SUBJECT: ISSUANCE OF AMENDMENT NO. 149 TO FACILITY OPERATING LICENSE NO.
DPR-23 REGARDING PRESSURE TEMPERATURE LIMITS - H. B. ROBINSON STEAM
ELECTRIC PLANT, UNIT NO. 2 (TAC NO. M87780)

AMENDMENT NO. 149 TO FACILITY OPERATING LICENSE NO. DPR-23 - H. B. ROBINSON
STEAM ELECTRIC PLANT, UNIT NO. 2

SAFETY EVALUATION BY THE OFFICE OF NUCLEAR REACTOR REGULATION
RELATED TO AMENDMENT NO. 149 TO FACILITY OPERATING LICENSE NO. DPR-23
CAROLINA POWER & LIGHT COMPANY
H. B. ROBINSON STEAM ELECTRIC PLANT, UNIT NO. 2
DOCKET NO. 50-261

3.1-1

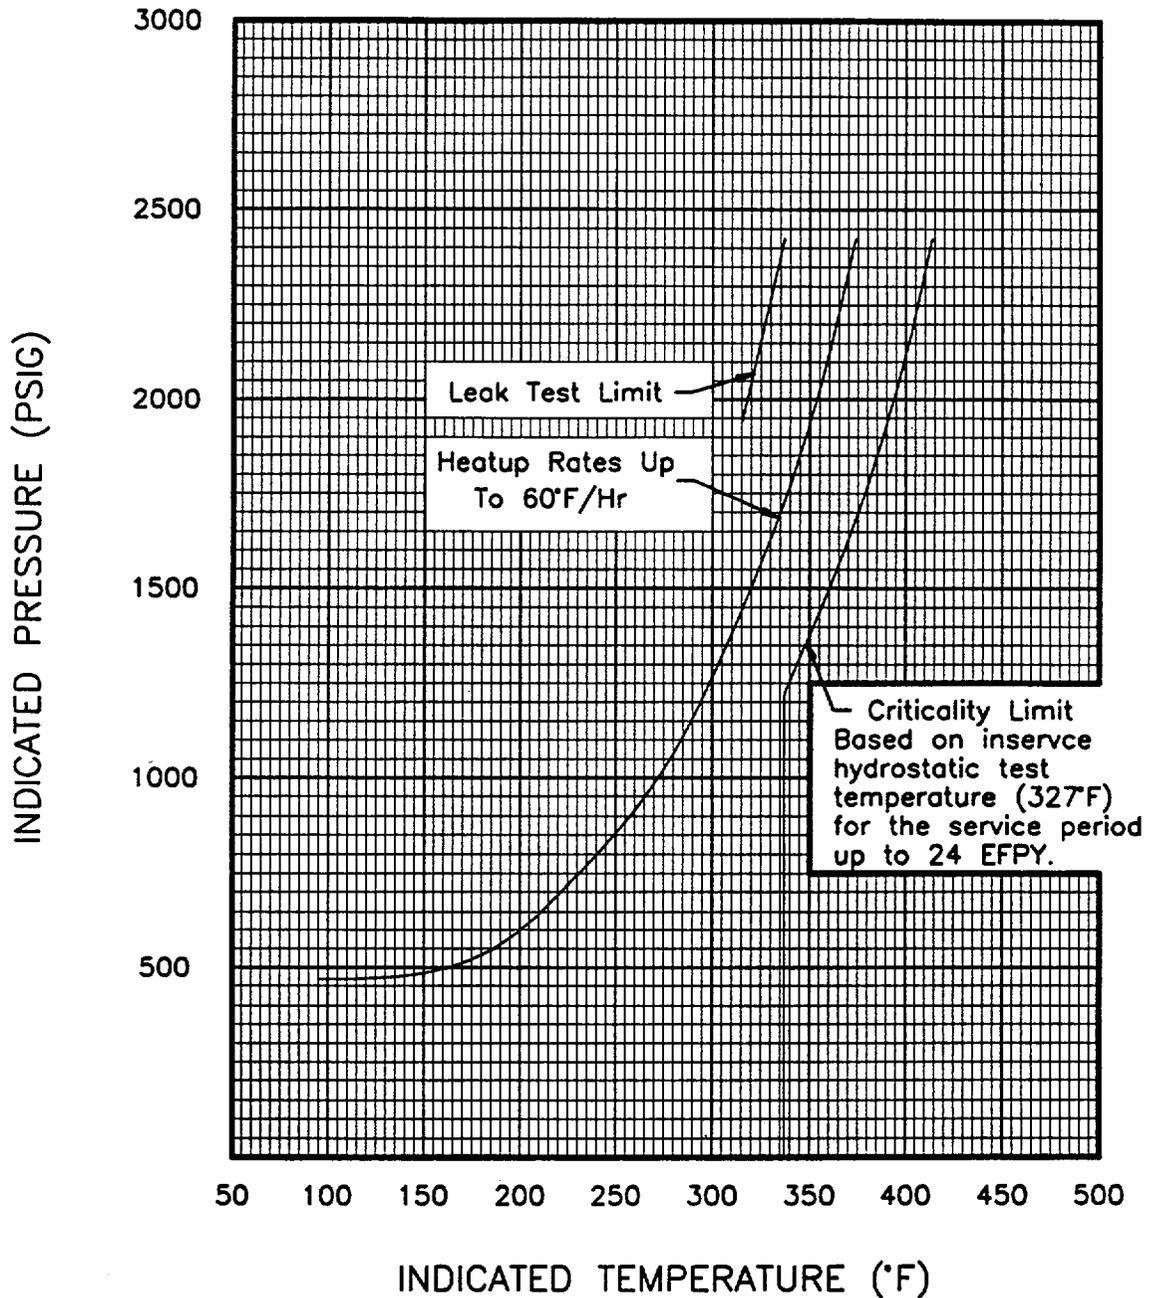
The Nuclear Regulatory Commission has issued the enclosed Amendment No. 149 to Facility Operating License No. DPR-23 for the H. B. Robinson Steam Electric Plant, Unit No. 2 (HBR). The amendment changes the pressure-temperature (P-T) limits from 15 to 24 effective full power years in the HBR Technical Specifications in response to your request dated September 15, 1993.

3.1.2.1 The reactor coolant pressure and the system heatup and cooldown rates (with the exception of the pressurizer) shall be limited in accordance with Figure 3.1-1 and Figure 3.1-2 (for vessel exposure up to 24 EFPY). These limitations are as follows:

- a. Over the temperature range from cold shutdown to hot operating conditions, the heatup rate shall not exceed 60°F/hr. in any one hour.
- b. Allowable combinations of pressure and temperature for a specific cooldown rate are below and to the right of the limit lines for that rate as shown on Figure 3.1-2. This rate shall not exceed 100°F/hr. in any one hour. The limit lines for cooling rates between those shown in Figure 3.1-2 may be obtained by interpolation.

- c. Primary system hydrostatic leak tests may be performed as necessary, provided the temperature limitation as noted on Figure 3.1-1 is not violated. Maximum hydrostatic test pressure should remain below 2350 psia.

Curves applicable for heatup rates up to 60°F/Hr for the service period up to 24 EFPY.

Applicable Up To 24 EFPY
